Independent Review of Tillegra Dam Hydrology

as described in the Environmental Assessment Report, August 2009,
and the Environmental Assessment Submissions Report, March 2010

Draft Report

NSW DEPARTMENT OF PLANNING

Figure 2: Mass Balance Diagram

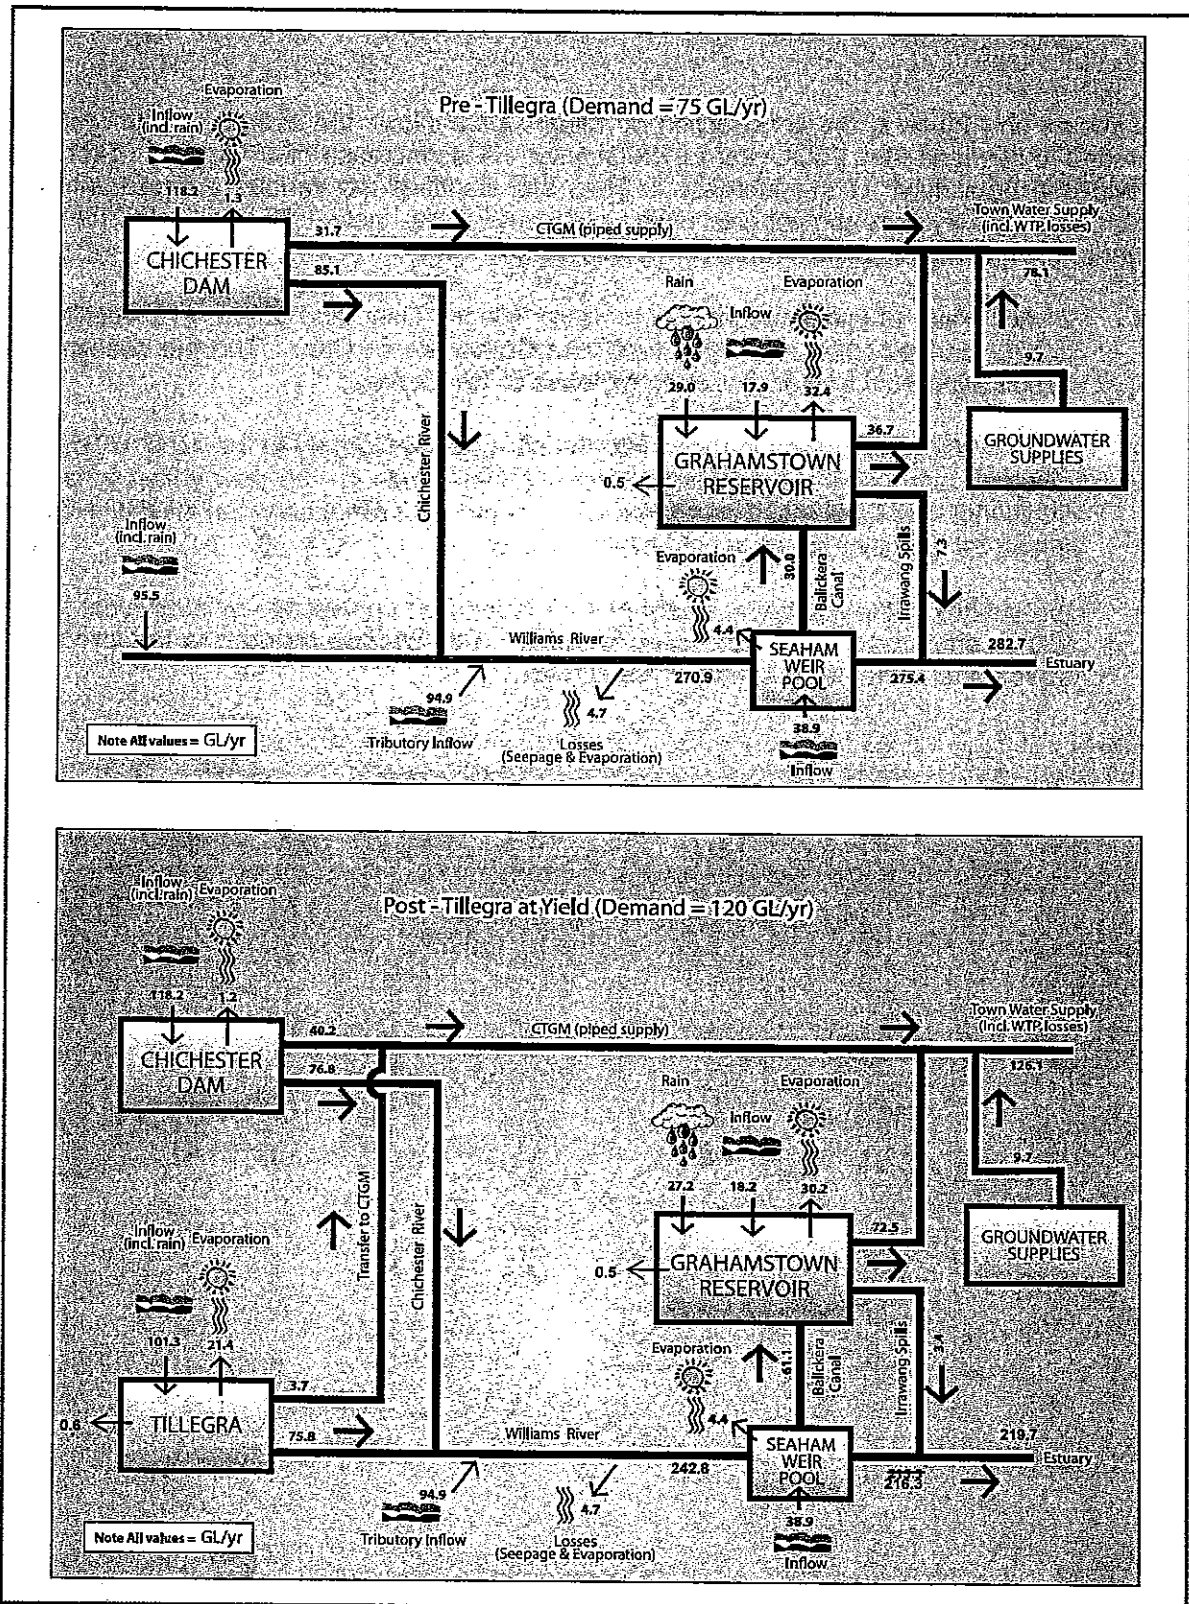
Average annual streamflow volumes at key locations were presented in Figure 10.7 of the EAR¹² using results from *SoMo*. This figure shows the 'pre-Tillegra' and 'post-Tillegra' conditions. A slightly revised version of this figure is presented in **Figure 2**, incorporating amendments made by the reviewer.

- (a) the source of the average annual values provided on the figure is not immediately apparent. The 'post-Tillegra' numbers do not correspond exactly to any of the *SoMo* data sets described in the *SoMo Report*. Nevertheless, the differences are minor and would be unlikely to alter any of the conclusions one draws from this figure. It is apparent that the model has been operated and refined on occasions during the preparation of the EAR and the EASR, and as a number of different data sets have been provided to the consultants documenting the EAR and EASR, it may be difficult to identify the true origin of all the information used;

- (b) the mass balance in all parts of the system illustrated in the figure is not necessarily preserved. Imbalances occur in a few locations and HWC have clarified¹³ these in response to questions asked by the reviewer. In particular:

- (i) there is an imbalance at Grahamstown Dam for 'pre-Tillegra' and 'post-Tillegra' conditions. In both cases, this is due to a change in storage in the Dam which was not reported in the original figures. These amendments have now been made in 'red' and are shown on **Figure 2**.

- (ii) a similar mass-balance error occurs with Tillegra Dam on the original figure and this has also been corrected in 'red' on **Figure 2**;
 - (iii) discussions with HWC have indicated that *SoMo* assumes approximately 10% of water specifically released from Tillegra for transfer to Grahamstown Dam is assumed to be inaccessible to the Balickera Pumps due to unforeseen operational constraints which may occur. On the advice of HWC, this additional loss stream is assumed to pass through the Seaham Weir pool and into the estuary. Accordingly, modifications to this part of the diagram have also been included in 'red' on **Figure 2**;

- (iv) in addition, spills from Grahamstown Dam find their way into the estuary and have been included in 'red' on **Figure 2**.
- (c) note that the modifications made in 'red' on **Figure 2** seek to resolve inconsistencies in Figure 10.7 of the EAR based on the *SoMo* results. Further corrections could be made to these results themselves (e.g. to improve the prediction of local catchment inflows to Glen Martin and Seaham Weir), but these have not been attempted by the reviewer.

(This is a reprint of Figure 10.7 from Volume 1 of EAR. Additions in 'red' have been made by the reviewer. Note that the local catchment inflows at Glen Martin and Seaham Weir are based on the *SoMo* results and the reviewer has not attempted to rectify the identified deficiencies in the simulation of these inflows. For example, the 270.9GL/yr inflow to Seaham Weir, pre-Tillegra, should probably be around 320GL/yr).

Figure 5: Probability of Dam Filling

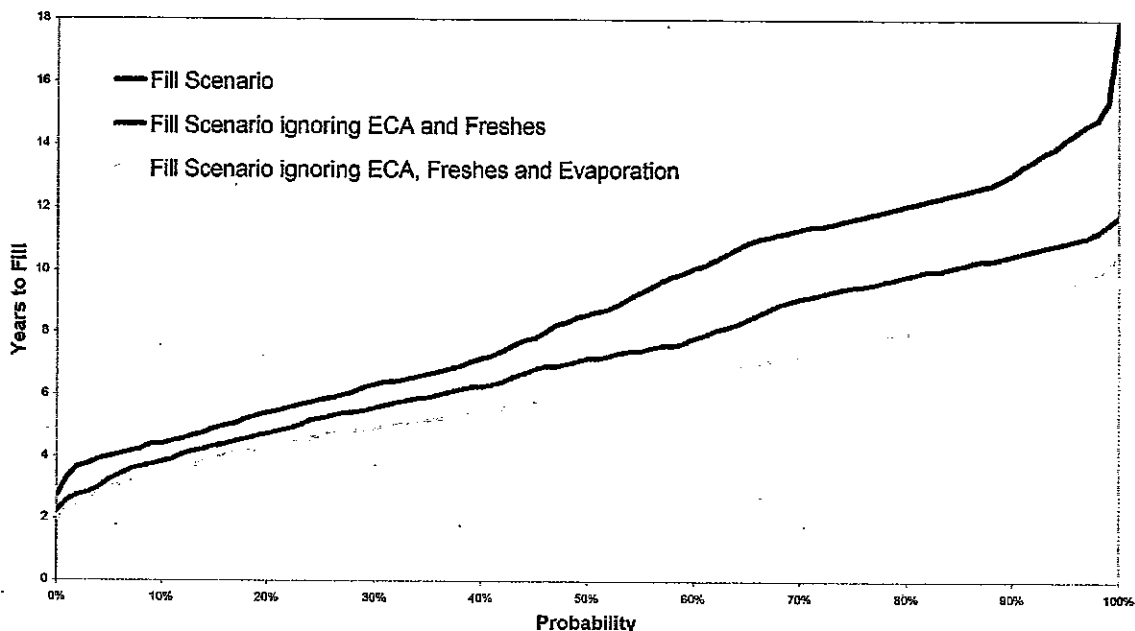
The probability of filling was determined and plotted in **Figure 5**. This indicates that, at worst, the dam could take almost 18 years to fill, which is broadly consistent with the predictions made in the *UNSW Report*. Whilst it could fill in as little as three years, the most likely filling estimate is approximately eight years. Note also that the allowance for releases and evaporation can have some impact on the filling time²³. This appears to be one reason for the different estimates of filling provided in the EAR.

Note also that if only the climate from 1980 to 2007 was considered, the filling time would still range from 3 to almost 18 years but the most likely filling time would now be 12 years.
